Title - Sujet Fire Suppression System&Fire Alarm Fire Suppression System and Fire Alarm Replacement	
Solicitation No. - N° de l'invitation EP076-201304/A	Amendment No. - N° modif. 008
Client Reference No. - N° de référence du client 20201304	Date 2021-03-30
GETS Reference No. - N° de référence de SEAG PW-\$\$\$FG-374-79676	
File No. - N° de dossier fg374.EP076-201304	CCC No./N° CCC - FMS No./N° VME
Solicitation Closes - L'invitation prend fin at - à 02:00 PM Eastern Daylight Saving Time EDT on - le 2021-04-13 Heure Avancée de l'Est HAE	
F.O.B. - F.A.B. Plant-Usine: <input type="checkbox"/> Destination: <input checked="" type="checkbox"/> Other-Autre: <input type="checkbox"/>	
Address Enquiries to: - Adresser toutes questions à: Vani-Machado, Alba	Buyer Id - Id de l'acheteur fg374
Telephone No. - N° de téléphone (873) 355-4048 ()	FAX No. - N° de FAX () -
Destination - of Goods, Services, and Construction: Destination - des biens, services et construction:

Addendum 3

T58 Building Fire Suppression System Questions
Solicitation – EP076-201304

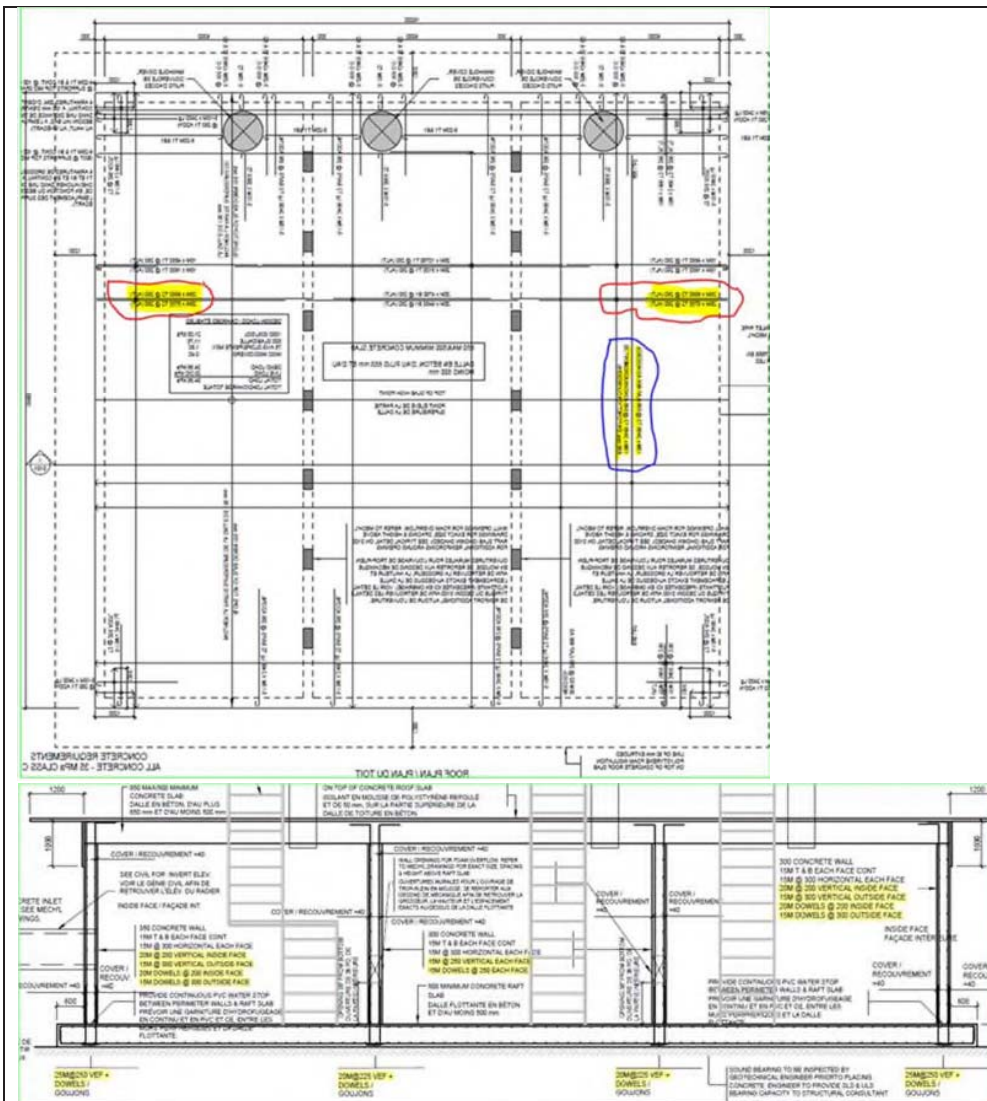
Q22 M201 drawing note #4 “cut out, cap and remove sections of existing abandoned effluent piping below slab” Can you please clarify what type sanitary pipe it is that is being capped?	
Q23 Detail 7/A.012 shows a different height of the storage tank concrete wall than what's shown on structural drawings. Please clarify required wall height?	A23 Dimensions shown on 7/A.012 match the structural drawings. The dimensions with the red circle is at the access hatches only and this matches the civil drawings, detail D07. The elevation on detail 7/A.012 match the elevation on one of the hatches, the other varies slightly. The dimensions on the other side of detail 7/A.012 dimensions the main part of the storage tank and match the structural. No change to the documents required.

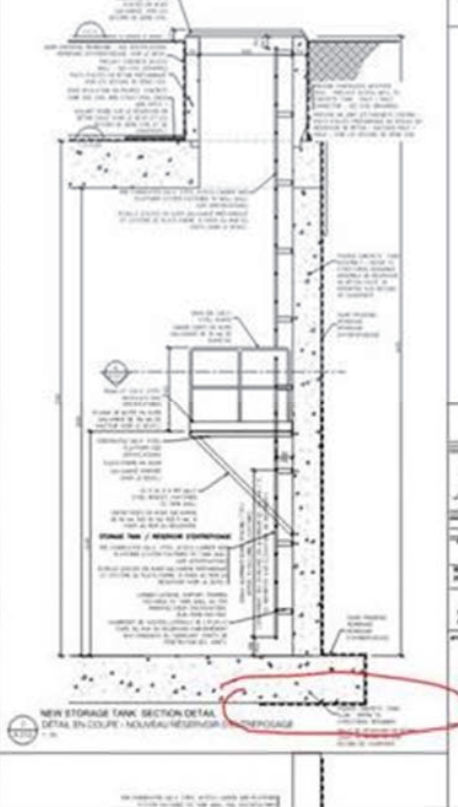
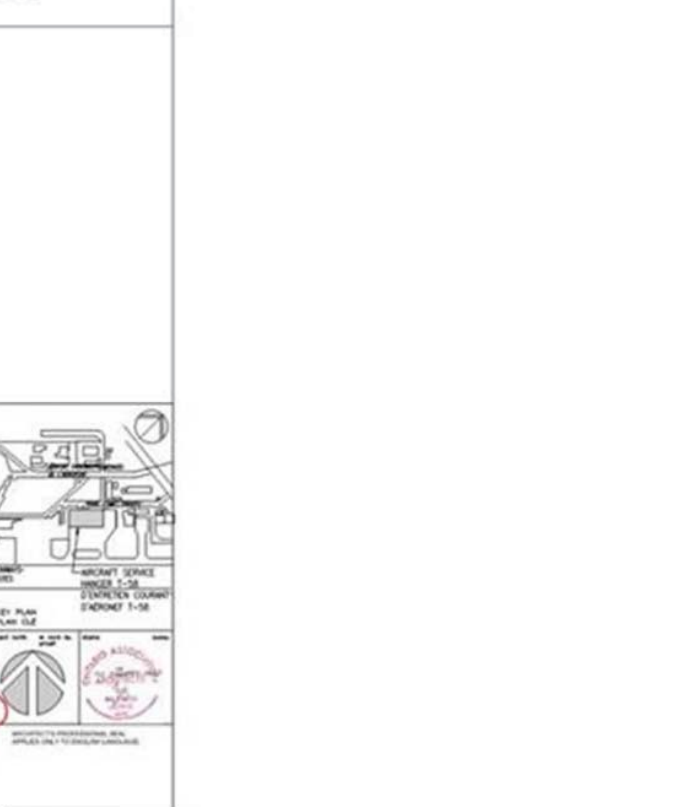
<p>Q30 In drawing S102, section A-A/S101 – CROSS-SECTION, the wall reinforcement is shown on the side of each wall. Also bottom of each wall is shown vertical reinforcement which is different from the vertical reinforcement shown on the side of the walls. See section “A-A” below. Can you please clarify which vertical reinforcement should be used?</p>	<p>A30 We have revised our wall reinforcement in section A-A/S102, refer to clouded areas on S102 in addendum for further details.</p>
